**IN THE DRAWINGS**

**REMARKS**

Applicant cancels claims 17 and 24. Claims 1-16, 18-23, and 25 remain pending in the application. Claims 6, 11, 18, and 25 have been withdrawn from consideration. Applicant amends the specification and Figs. 8-9 and 18-28 for clarification and to correct errors, and amends claims 1-2, 5, 7-8, 10, 13, and 20 for clarification. No new matter has been added.

FIG. 8

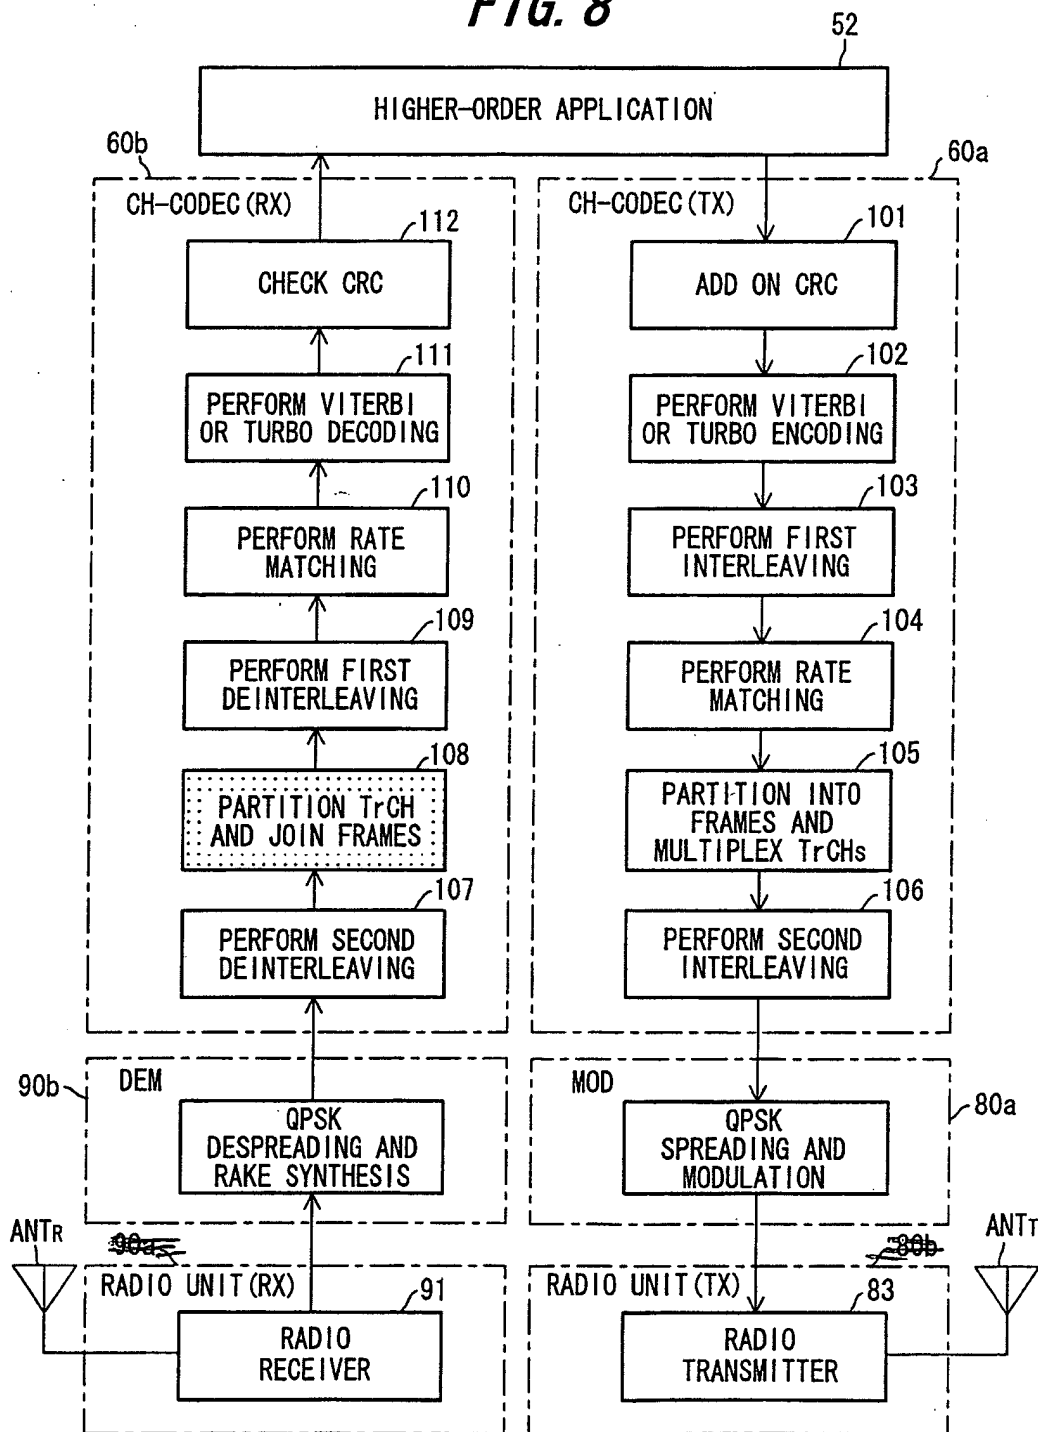
The Examiner objected to the drawings under 37 CFR 1.84(p)(4) for having separate designations "90a" and "91" for "Radio Receiver," and designations "80b" and "83" for "Radio Transmitter." Applicant amends Fig. 8 and its corresponding description in the specification to remove designations "90a" and "80b."
